CWM CHEMICAL SERVICES, INC.

CHICAGO INCINERATOR FACILITY
CHICAGO, ILLINOIS

FINAL
RCRA FACILITY INVESTIGATION
REPORT

FINAL DETERMINATION REGARDING THE NEED FOR A CORRECTIVE MEASURES STUDY CHEMICAL WASTE MANAGEMENT - CHEMICAL SERVICES, INC. CHICAGO INCINERATOR FACILITY

CWM CHEMICAL SERVICES INC. CHICAGO INCINERATOR FEB. 23 1993	
FIGURE 4-1 SIMULATED GROUNDWATER FLUX INTO LAKE CALUMET	
DRN. BY MAR	PROJ. NO. 13963-055
DATE OCT. 1993	DAMES & MOORE

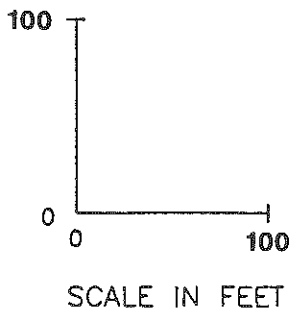
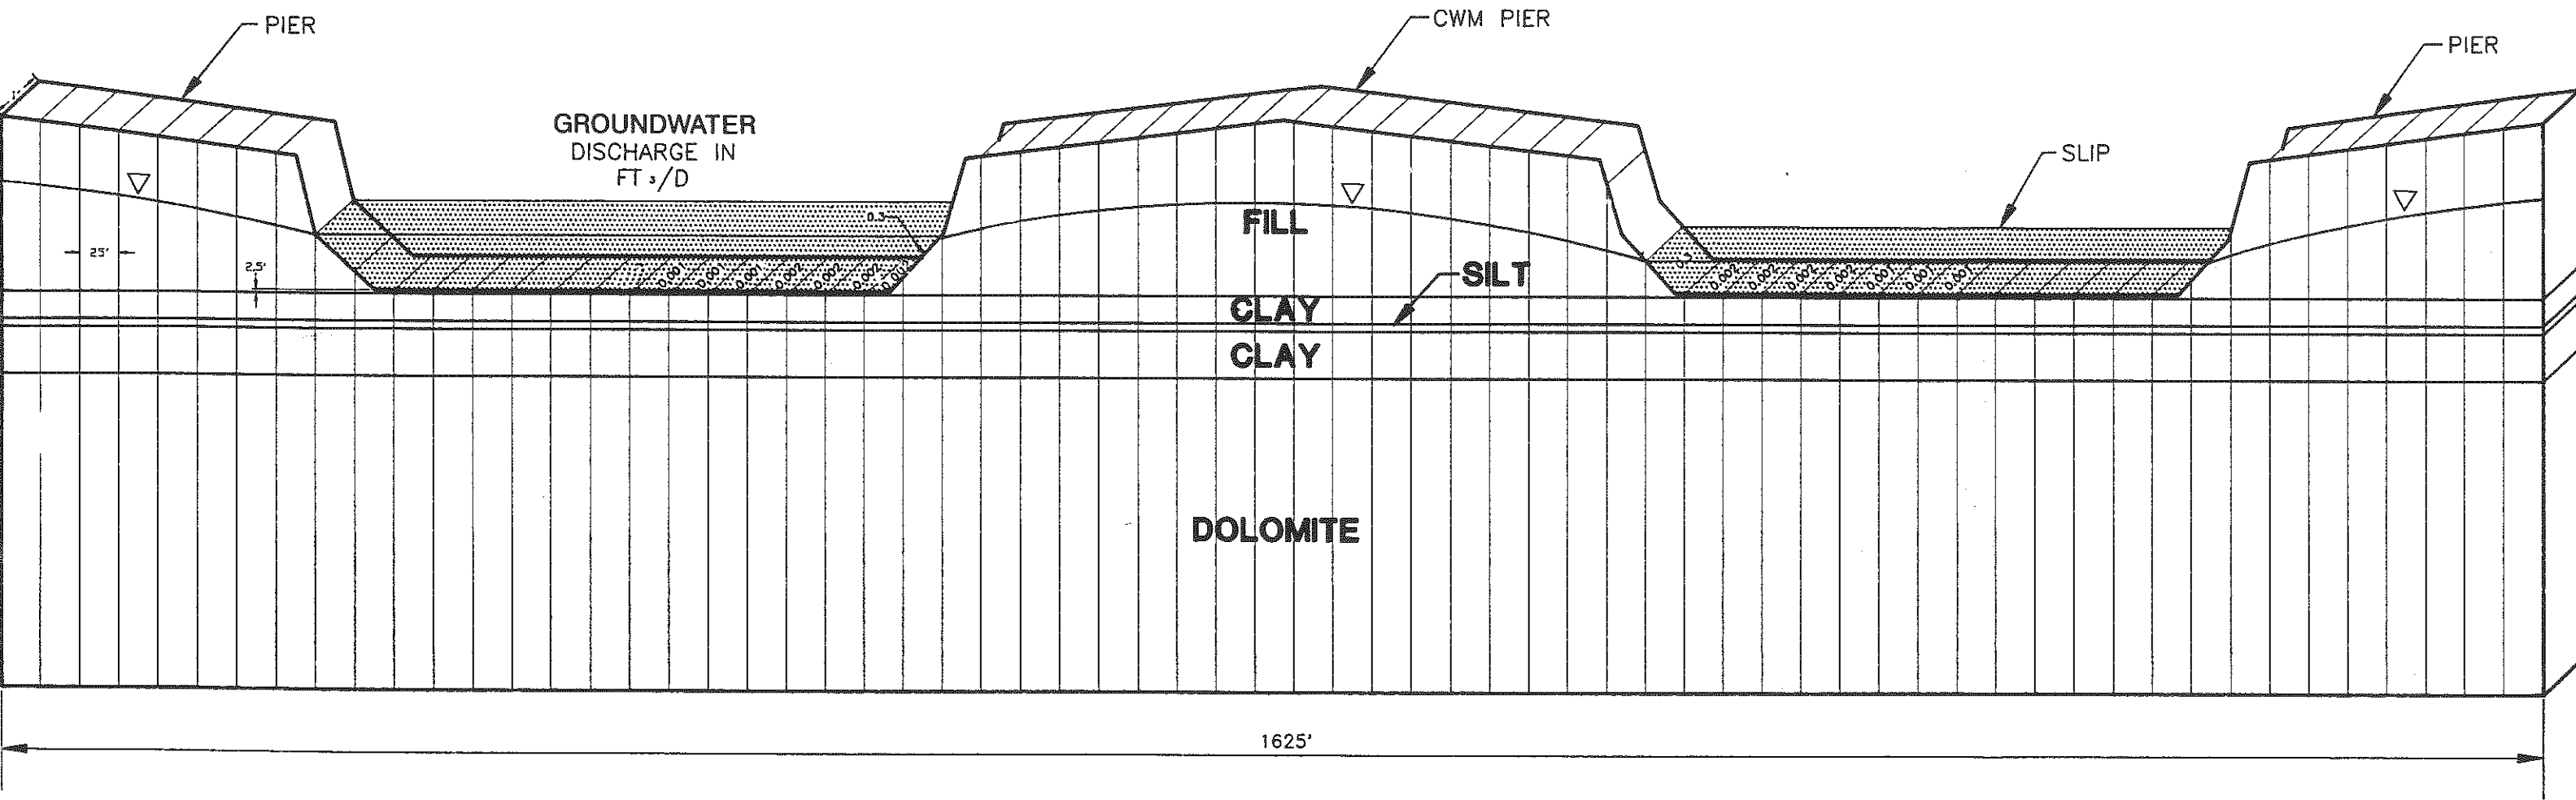
1. Section 4.2.5.1, Page 4-64. The textual reference to Figure 4-2 has been changed to Figure 4-1.
2. Section 4.2.5.1: Figure 4-2 was renamed to Figure 4-1 "Simulated Groudwater Flux into Lake Calumet" and the following additons were made to this figure:

- a. A 1-foot wide section of the aquifer, oriented north-south (left and right respectively) is appropriately indicated in Figure 4-1.
 - b. The groundwater discharge and water table surface are represented on Figure 4-1.

- c. The fluxes shown on the north side of the pier (left as one views Figure 4-1) have been corrected to match those presented in Table 4-7.
3. Section 4.2.5.1, Page 4-66. The text has been corrected to indicate "...a no-flow condition on all four sides and at the base." and "...the north and south model boundaries (left and right respectively), ..."
